CITY OF LA VISTA
MAYOR AND CITY COUNCIL REPORT
SEPTEMBER 15, 2020 AGENDA

Subject:	Type:	Submitted By:
PUD SITE PLAN AMENDMENT LOTS 1-4 ECHO HILLS REPLAT FOUR WEST MANAGEMENT, LLC	◆ RESOLUTION ORDINANCE RECEIVE/FILE	CALE BRODERSEN ASSISTANT PLANNER

**CITY OF LA VISTA
PLANNING DIVISION
RECOMMENDATION REPORT**

CASE NUMBERS: PPUD20-0003;

PUD Site Plan

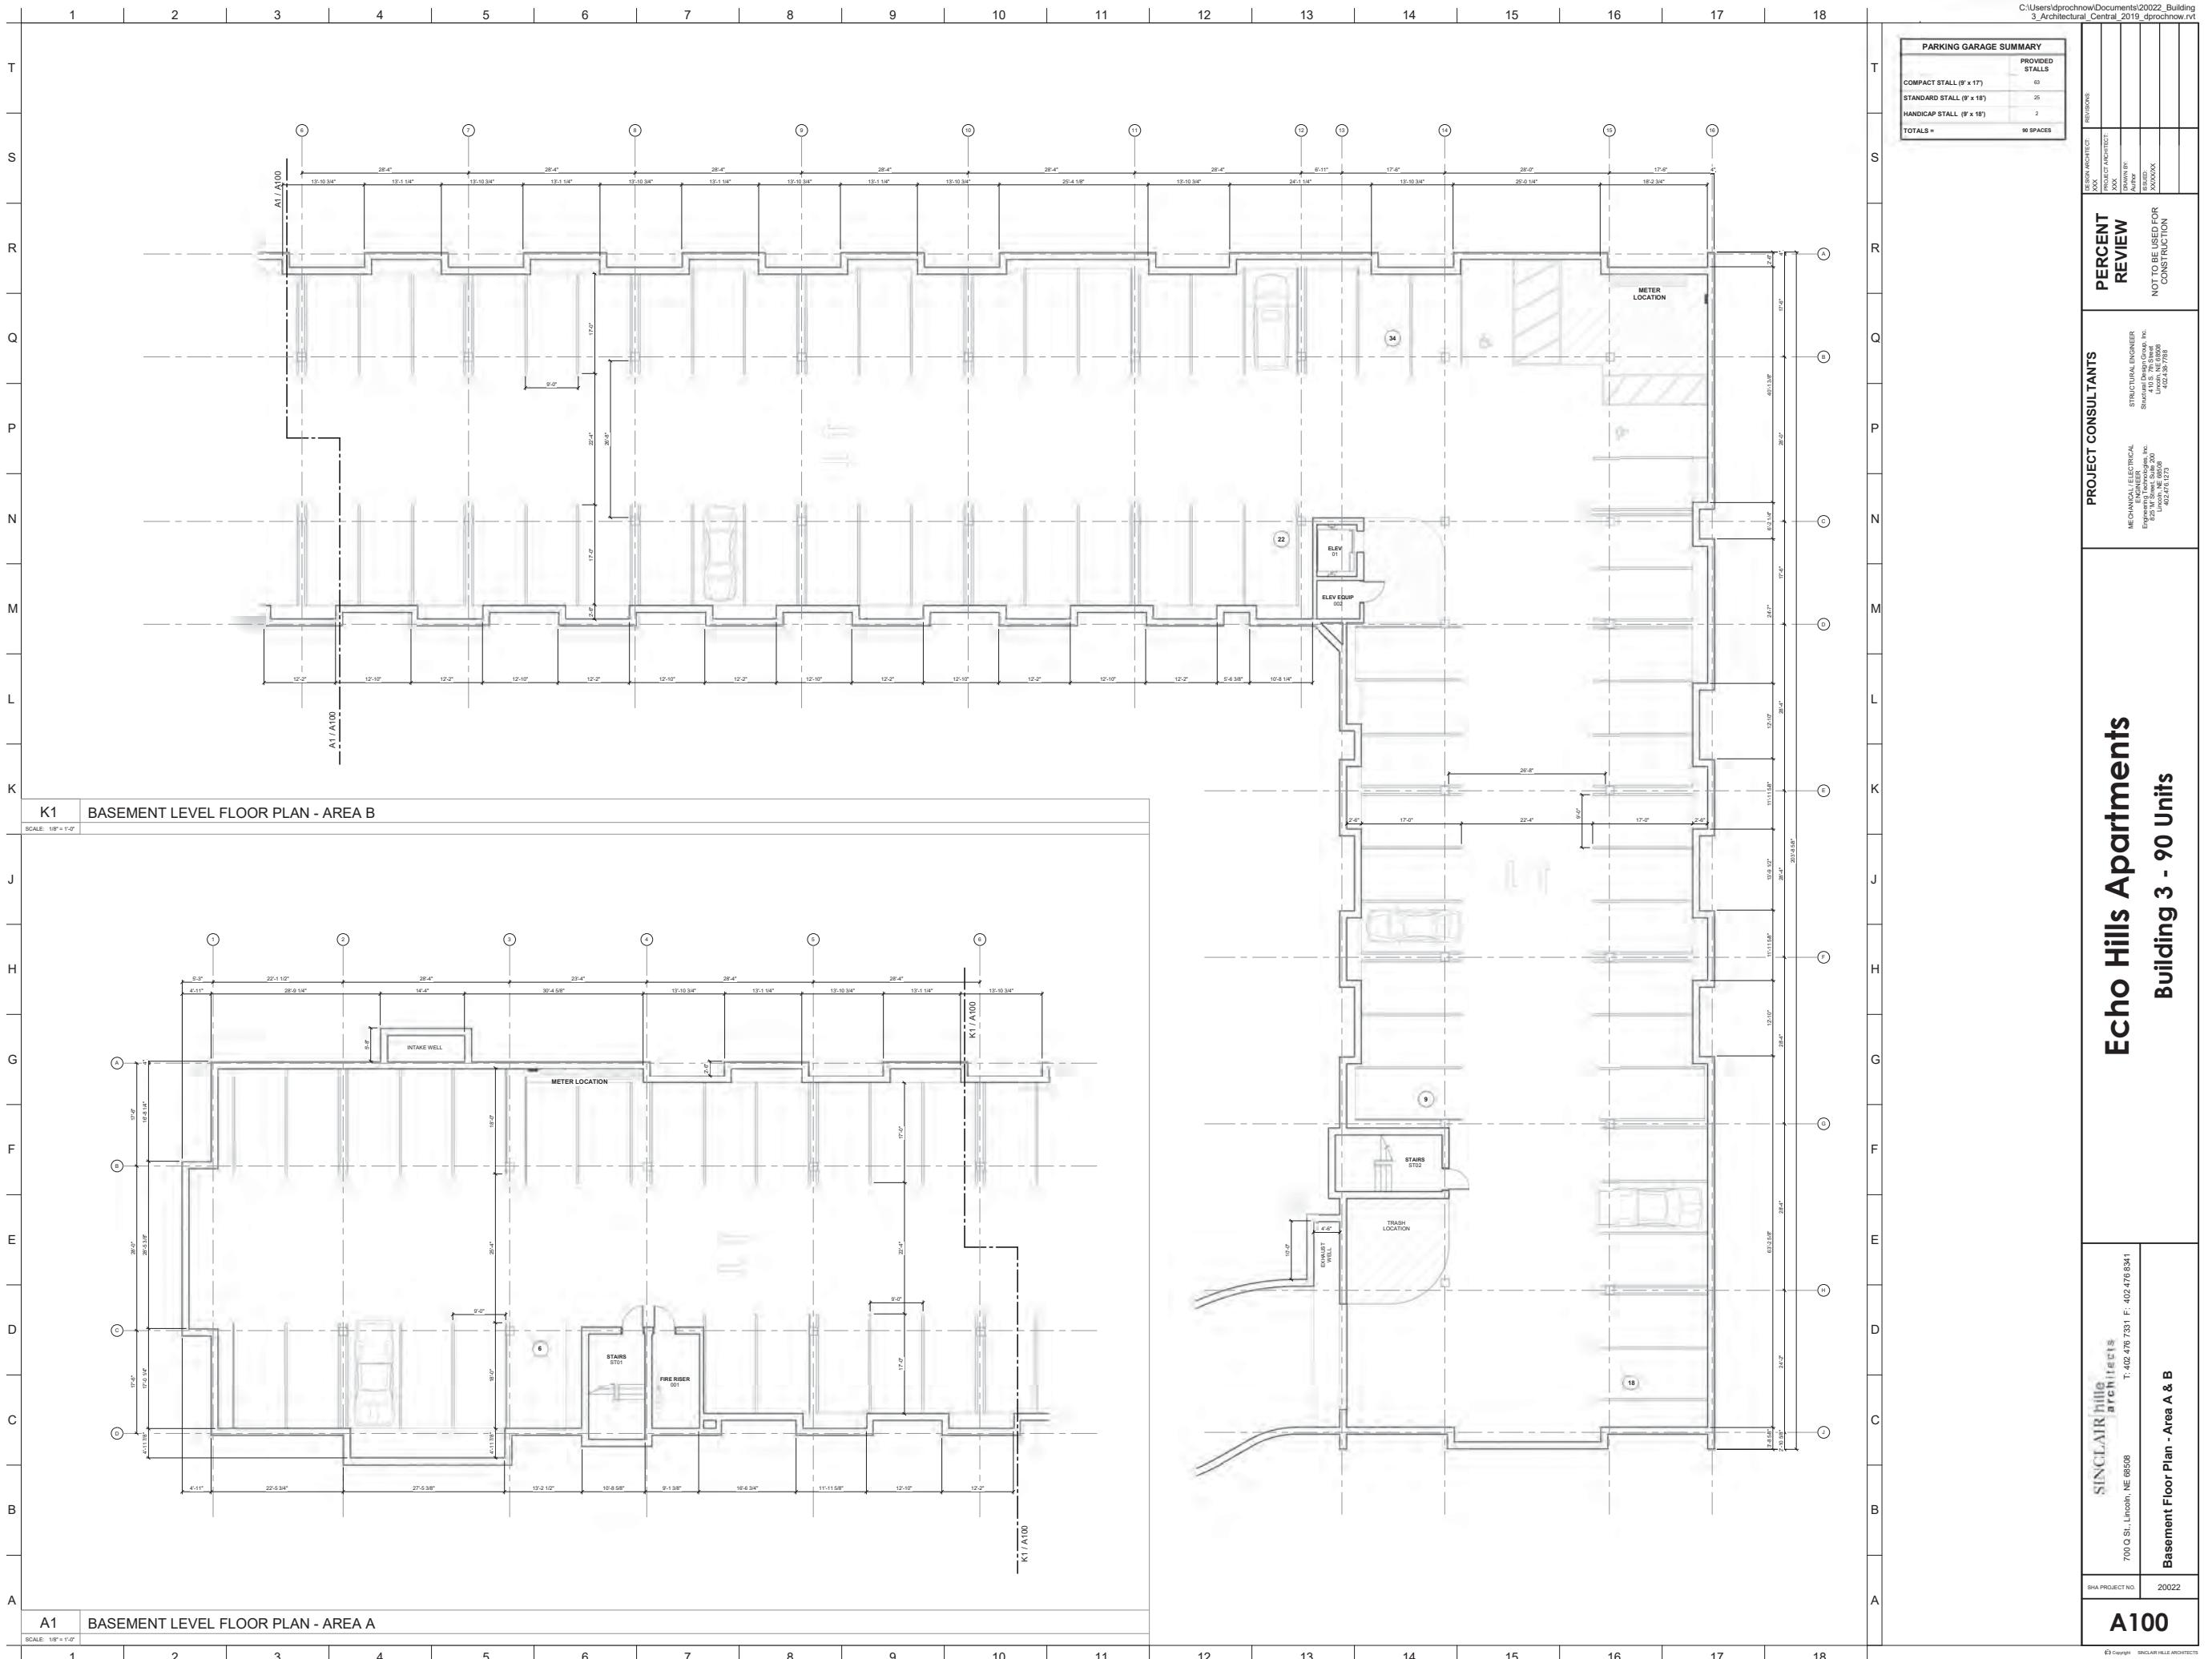
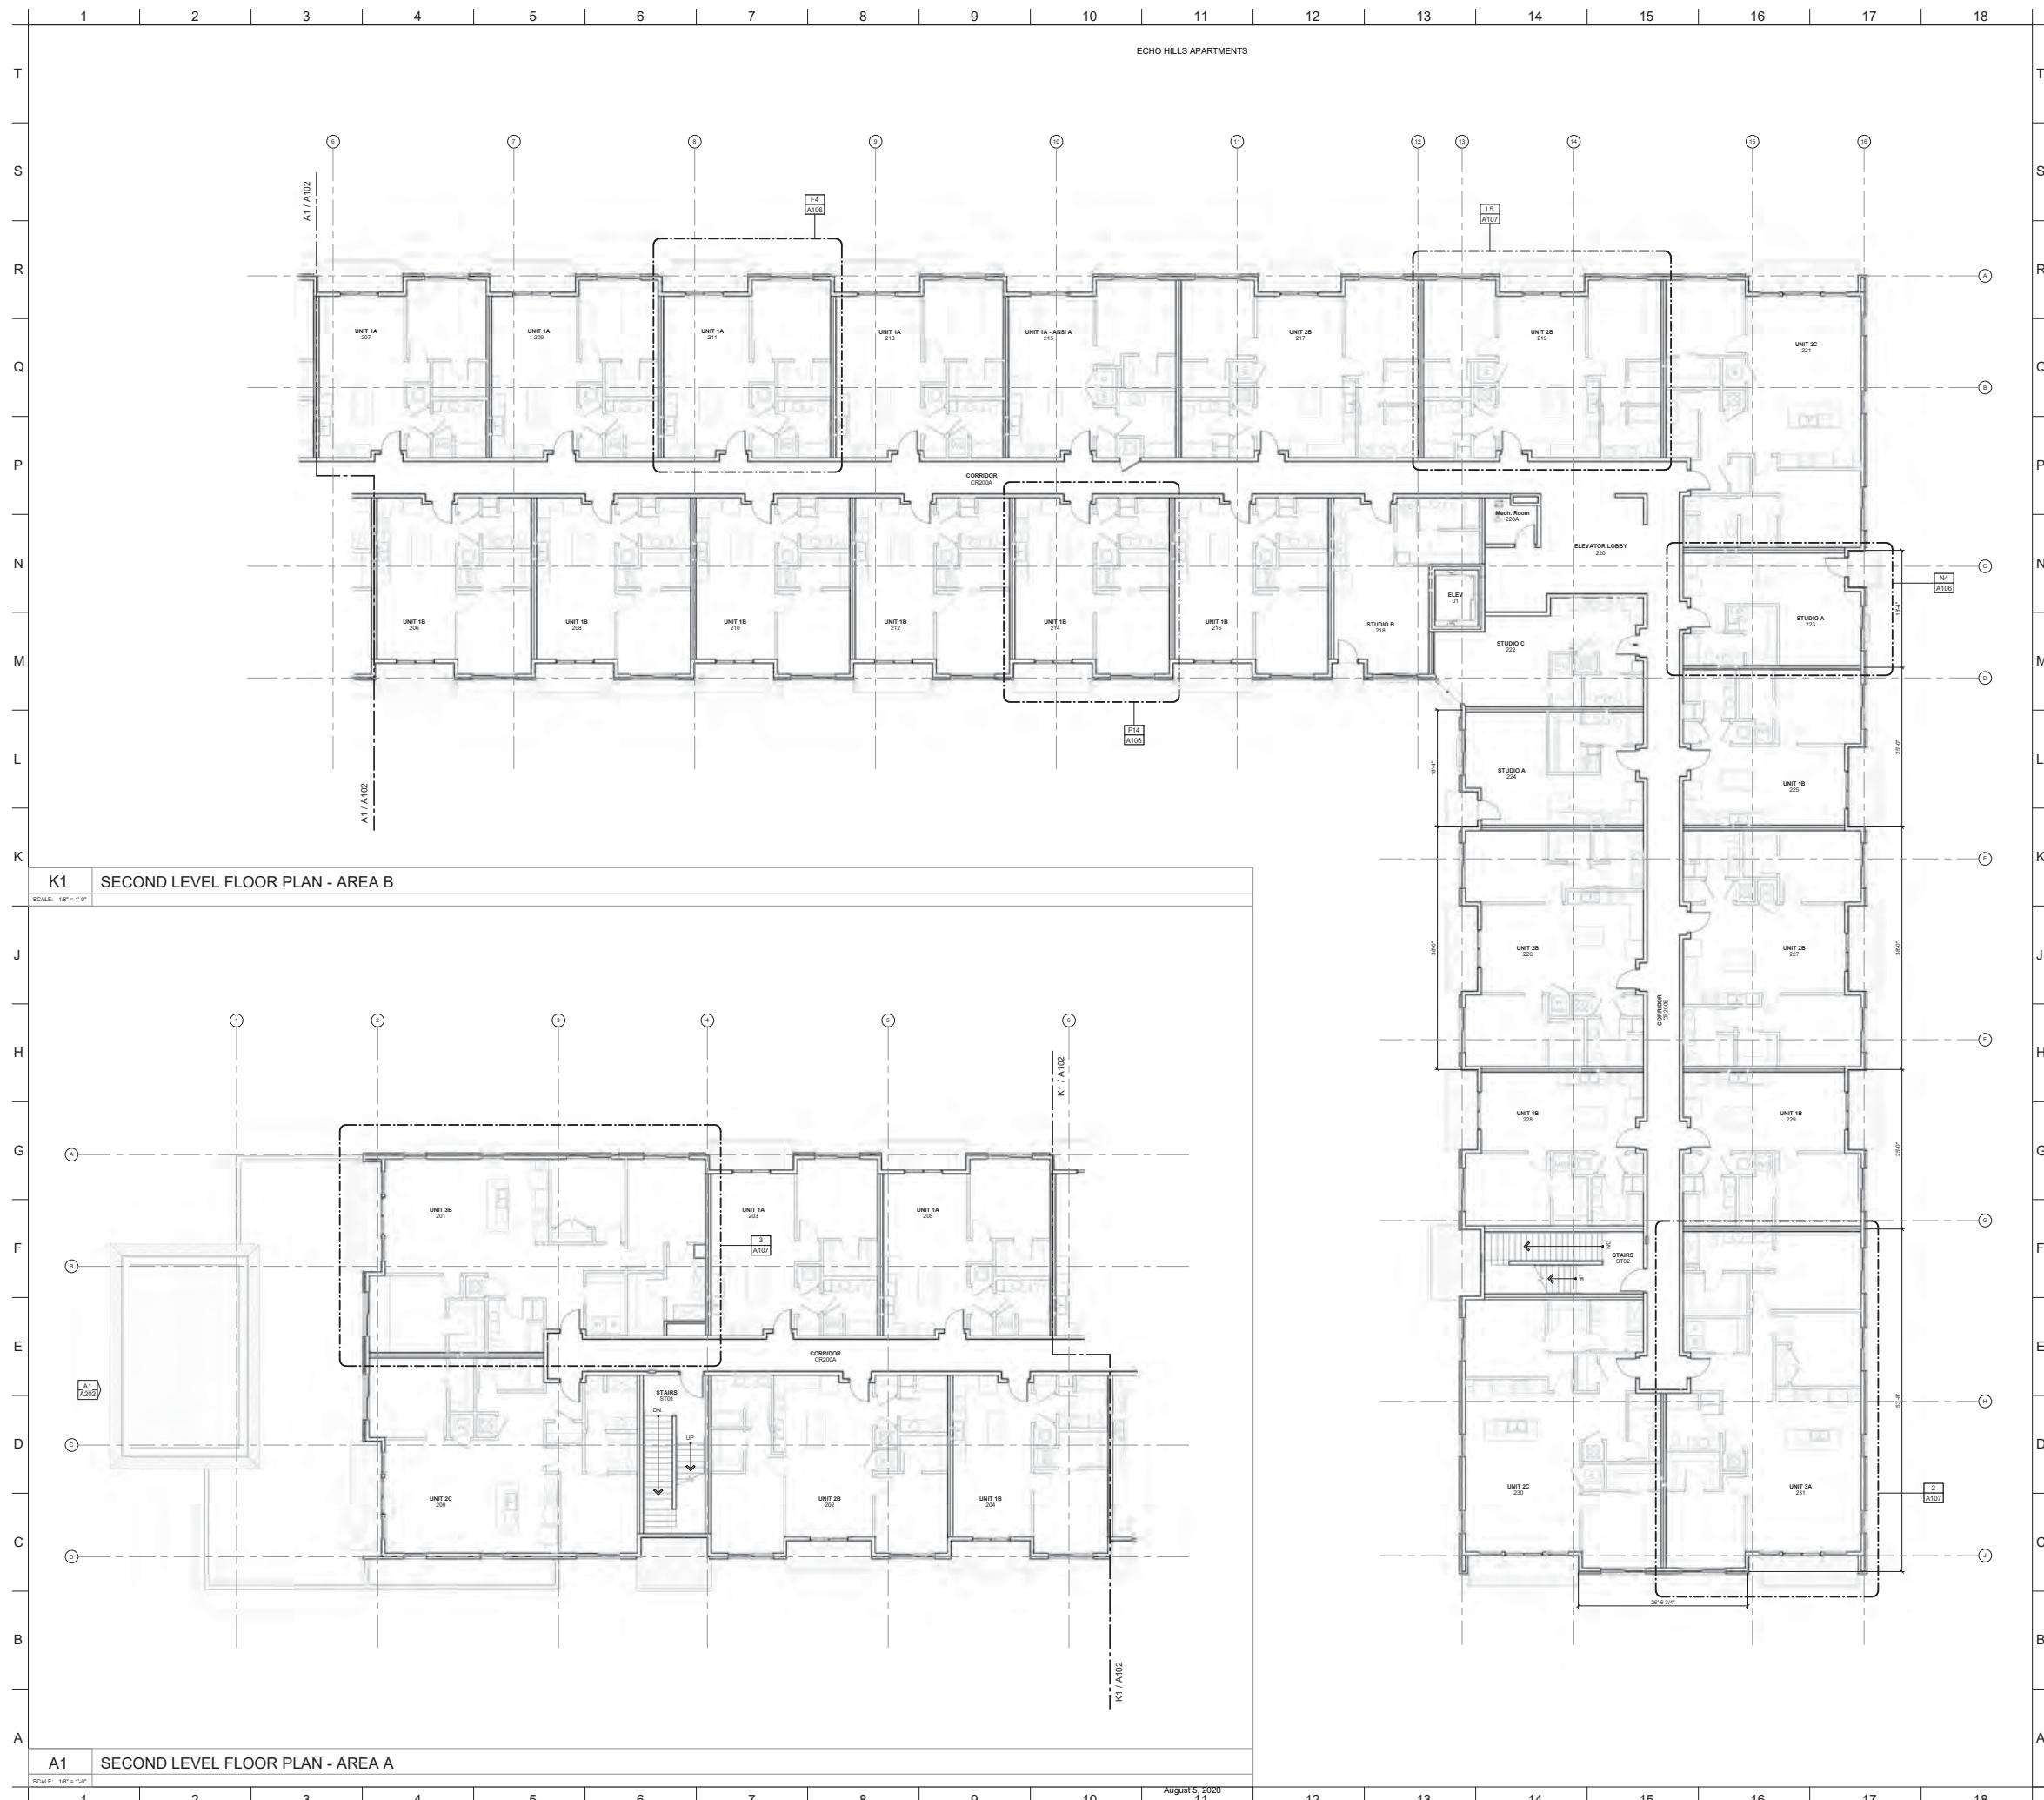
As building design has progressed for the buildings on Lot 1 (assisted living and memory care facility) and Lot 2 (apartments), the applicant has requested an amendment to the PUD Site Plan to allow for changes in the provided off-street parking due to architectural constraints. These changes include alternative dimensions for compact parking stalls contained in the underground parking garage for apartment building #3 and a reduction in the overall parking stall count, which would still exceed the minimum amount required by the La Vista Zoning Ordinance.

G. PURPOSE OF REQUEST: Allow for changes in the number of provided parking stalls and the stall configurations in the previously approved PUD Site Plan.

D. The City Engineer recommends approval of the proposed alternative compact stall dimensions, considering that all 91 stalls in the underground garage for apartment building #3 are classified as compact, as denoted on the PUD Site Plan attached to this report.
